81 Gray Street
Portland, Maine

Renovations to
Stairs and
Deck

City of Portland, Maine - Building or Use Permit Application
389 Congress Street, 04101 Tel: (207) 874-8703, Fax: (207) 874-8716

Re: Porch and Deck Reconstruction – 81 Gray Street

81 Gray Proposed Deck TO REPLACE EXISTING DECK

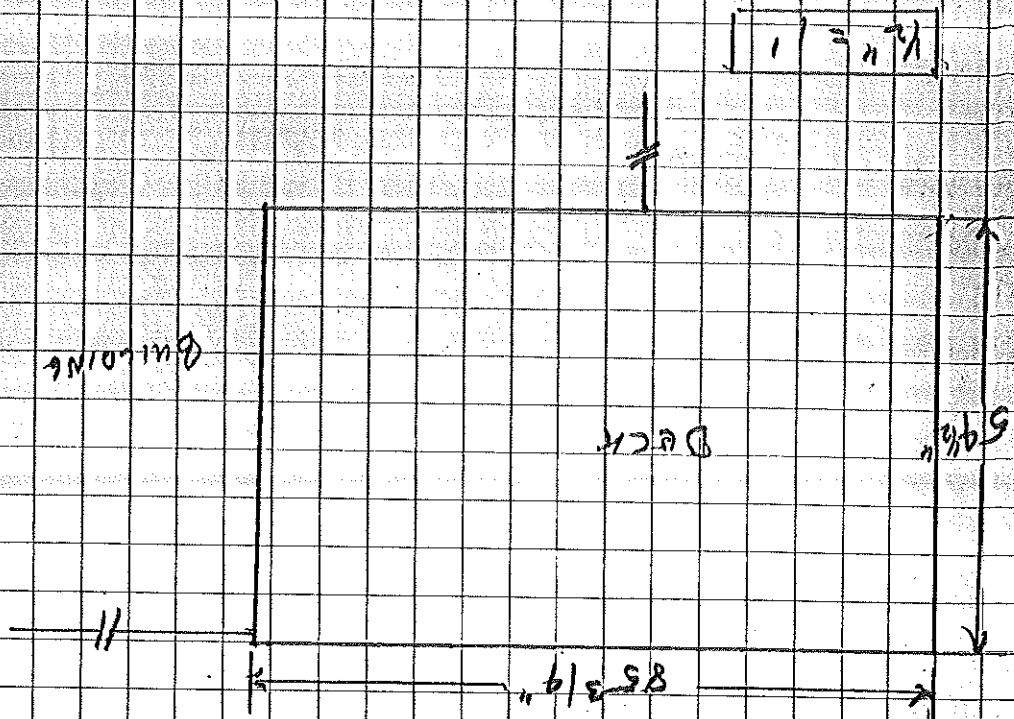
38. *HISTORIC PRESERVATION SHALL APPROVED THESE PROPOSED STAIRS AND DECK. BEFORE WORK IS STARTED.*

Proposed Deck:

- Same dimensions (85 3/4" x 54 1/2")
- 2 x 8 joists
- Doubled 2 x 8 headers
- Standard metal joist hangers
- 4 x 6 posts
- 5/4 x 6 decking
- 2 x 2 square spindles @ 3" spacing
- 2 x 4 top and bottom rails
- 4 x 4 turned posts for railings
- Rail height - 36"
- (All materials pressure treated)
